SPB Number: 2024.0102**INTERIOR UPDATES**

THE CLIPS BELOW ARE TAKEN FROM THE STANDALONE PROTOTYPEIssued: 05/10/2024**STANDARD PLAN BULLETIN NOTICE**
RaceWay Engineering and Construction Division

- Sheets: A152, A501, M120
- Attachment: A152, A501, M120

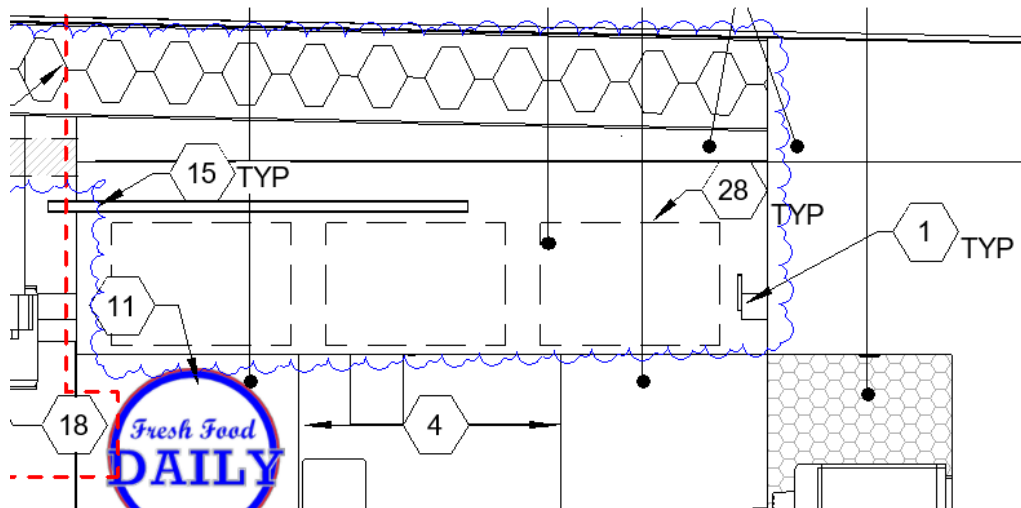
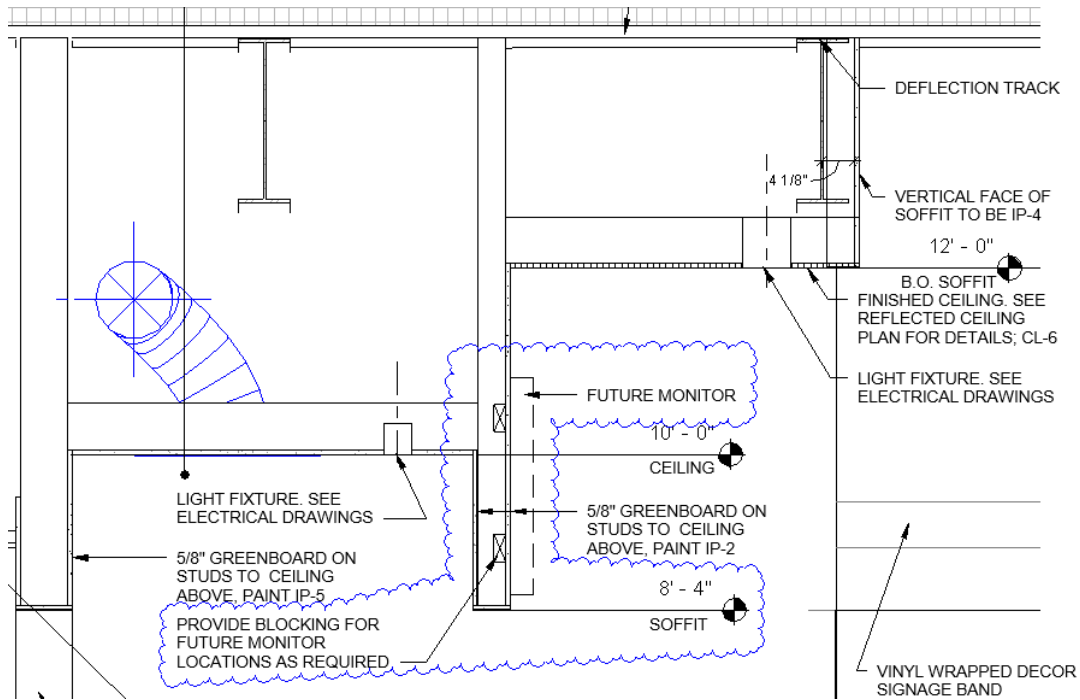
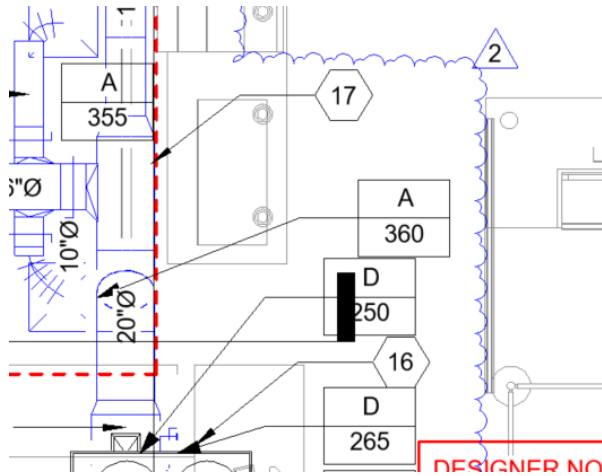
2. **UPDATES TO FOOD SOFFIT:** Create perimeter drop down around edge of soffit. Inside soffit to stay 10'-0" AFF and edge band to be at 8'-4" to align with adjacent soffit over Coke Freestyle. Include dashed TVs on A300 with notes for "Future TV Monitors."

SHEET KEYNOTES	
16	BOTTOM OF DUCTWORK SHALL BE INSTALLED MIN. 11'-0" A.F.F. TO AVOID OBSTRUCTION OF RACEWAY SIGN BEHIND CASHWRAP.
17	DASHED OUTLINE REPRESENTS LOW PART OF SOFFIT. INSTALL SUPPLY AIR DUCTWORK WITHIN LOW SOFFIT. COORDINATE WITH ARCHITECTURAL DRAWINGS.

- Sheets: A002, A003, A120, A130, A140, A150, A501, E100, E110
- Attachment: A140, A501, E100, E110

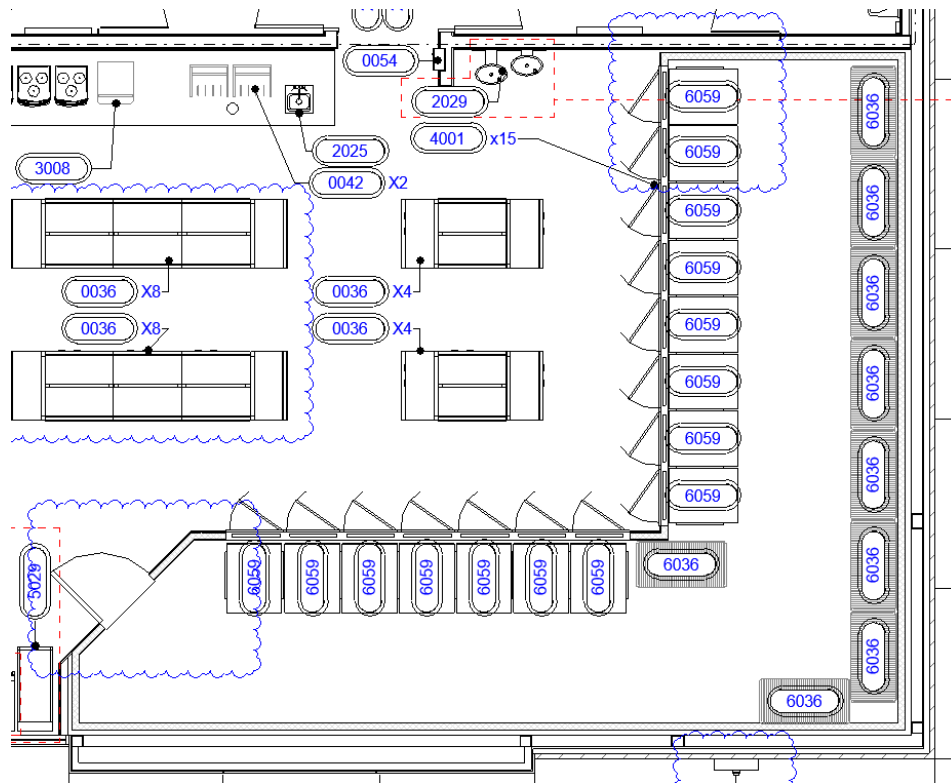
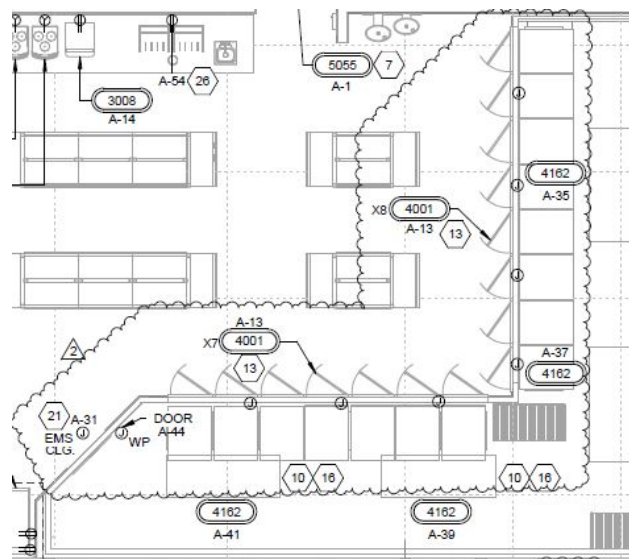
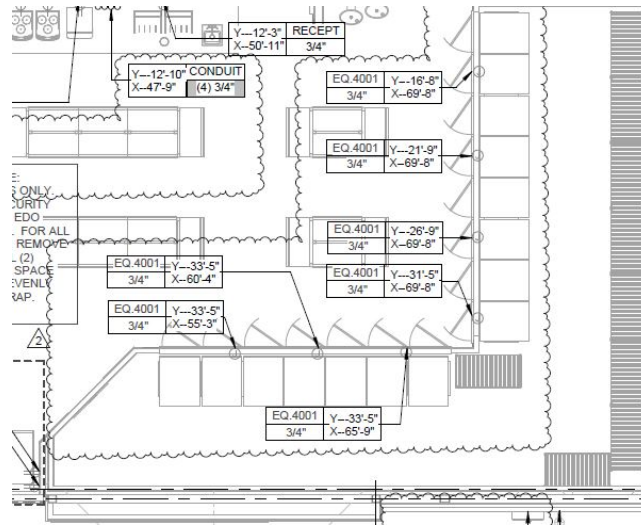
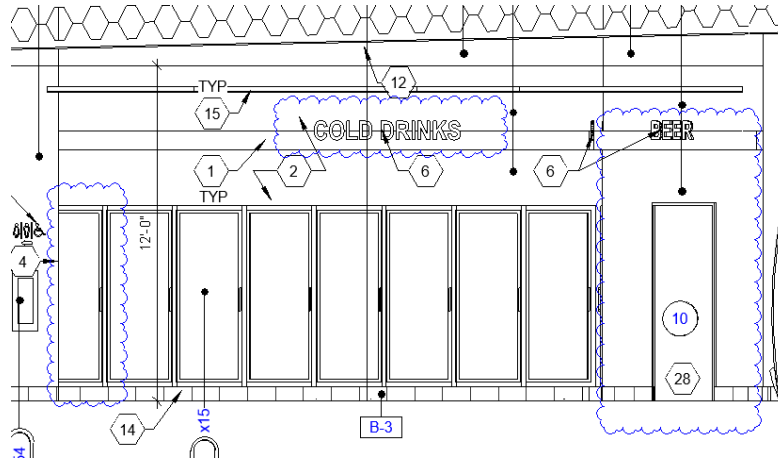
3. **COOLER UPDATE:** Relocate entrance door and move interior equipment to accommodate new layout.
